# Access Compliance Report

## Public Rights-of-Way

### (Curb Ramps)

Intersection ID: 10040511	Main Street: W_4TH_ST	Cross Street: N/A	Location: W
ADA ID: 101D372B7A81	Ramp Type: BlendTrans1	Initial Pass/Fail: Fail	Overall Compliance: No
		Severity Score: 12.5

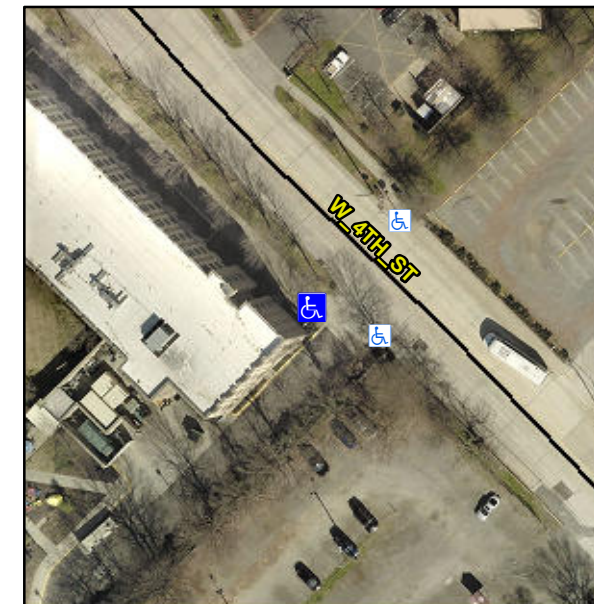
**Not Found, R304.5.3**

Compliance	Description	Data	Compliance	Description	Data
N/A	Ramp Length (in)	101.0	Yes	BlendTrans Slope (%)	3.1
Yes	Ramp Width (in)	50.0	No	BlendTrans XSlope (%)	6.1
N/A	Flare Type LT	N/A	N/A	Flare Type RT	N/A
N/A	Flare Slope LT (%)	N/A	N/A	Flare Slope RT (%)	N/A
N/A	Flare Traversable LT?	N/A	N/A	Flare Traversable RT?	N/A
N/A	Landing Length (in)	N/A	N/A	DWS Provided?	N/A
N/A	Landing Width (in)	N/A	N/A	DWS Contrast?	N/A
N/A	Landing Slope (%)	N/A	N/A	DWS Length (in)	N/A
N/A	Landing X Slope (%)	N/A	N/A	DWS Full Width?	N/A
N/A	Landing Curb? (Y/N)	N/A	N/A	DWS Offset (in)	N/A
N/A	Shared Landing?	N/A			
N/A	Gutter Ponding?	N/A	N/A	Gutter Slope (%)	N/A
N/A	Gutter Lip Ht (in)	N/A	N/A	Gutter X Slope (%)	N/A
N/A	Painted X Walk1?	No	N/A	Painted X Walk2?	No
	X Walk 1 Direction	To SE		X Walk 2 Direction	To NE
	X Walk 1 Width (in)	N/A		X Walk 2 Width (in)	N/A
	X Walk 1 Slope (%)	2.7		X Walk 2 Slope (%)	1.3
	X Walk 1 X Slope (%)	3.5		X Walk 2 X Slope (%)	3.0

N/A	Ramp inside XWalk1?	N/A	N/A	Ramp inside XWalk2?	N/A
	Road Slope (%)	4.5		Clear Space?	N/A
	Road X Slope (%)	1.1	N/A	Clear Space to XWalk (in)	N/A
N/A	Any Obstructions?	N/A	N/A	Storm Grate/Utility Hazard?	N/A
	Obstruction Type			Storm Grate/Utility Type	
		N/A			N/A
			N/A	Surface Condition? (G/P)	N/A
			No	Curb Slope (%)	17.1

**Remove & Replace Curb Ramp With Two New Directional Ramps or Equivalent.**
